Barn Bluff Park Master Plan

Concept & Feedback Review Meeting

HKGI Office - Feb 12, 2016

HKGi Office - Feb 24, 2016

CONCEPT OVERVIEW

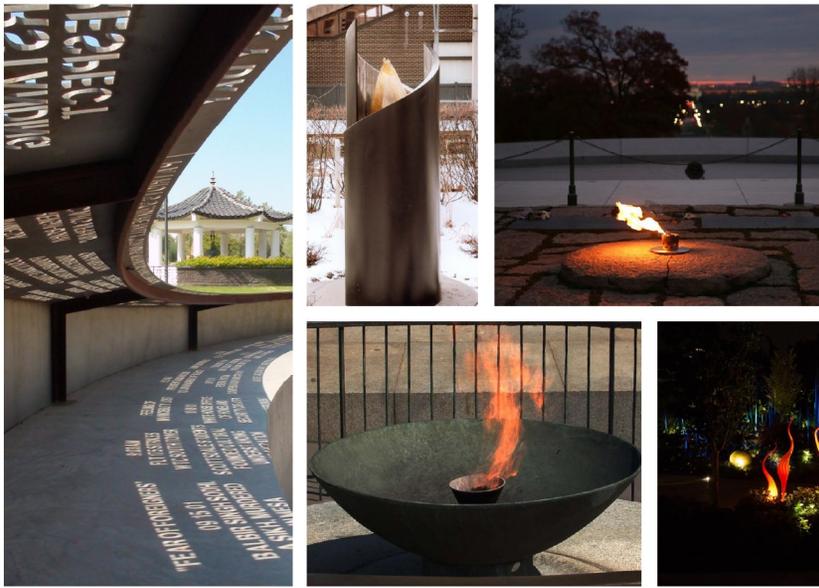
- Parking lot stays within city owned property and achieves 20 stalls
- Confirm parking lot turning radii
- Is there another parking lot configuration that can achieve more parking spaces?
 - Steve sent a concept- Sarah drew to scale- only achieves 18 stalls
- Though-drive to Xcel property for additional 55 spaces on natural surface (overflow parking)
- Parallel spaces along 5th Street to potentially double as pull off area for buses?
- Explore an appropriate turnaround for buses (likely by Izaak Walton League/Xcel drive)
- Additional parking along 5th Street located north near Izaak Walton property and south of Hwy 61 overpass (would require coordination with MnDOT to formalize) – Master Plan to include these as labeled areas or diagram
- Added bike parking near the restrooms

- Plaza links pumphouse area with base of Kiwanis stairs
- Interpretation along water reservoir walls and near pumphouse
- Kiosk with park info and trail maps at pumphouse entry and at base of stairs
- Lawn area minimized....possible circular form; link with contemplative space or pathway
- Service vehicle access to pumphouse maintained
- Location for potential Native/Dakota monument opportunity to be determined. Discussed the notion of the memorial being a space/place. Explore the concept of integrating the lawn area with the memorial. Discuss with Art
 - Sarah to provide Brian with concept and examples for discussion
- Repeat use of circular space and design materials for key locations, such as plaza space, entries, junctions, and overlooks. Think of this as a family of spaces/materials/symbols
- Integrate stormwater infiltration with planting areas at plaza (raingardens)

- Entry location to park moves into forested area (from profane to sacred) and starts ascent to trail junction, with option to continue straight on ADA trail to base of Kiln (a no-outlet trail)
- Park entry path climbs with long ramped treads with 8% grade to circular trail junction
- Eliminate trail to upper kiln area from junction

- Formalize trail between Quarry Trail and top of kiln where trail ends (no outlet)
- Use as location for additional interpretation for kiln
- Design with rail or barrier and plantings to keep people off the kiln and avoid visual impacts below
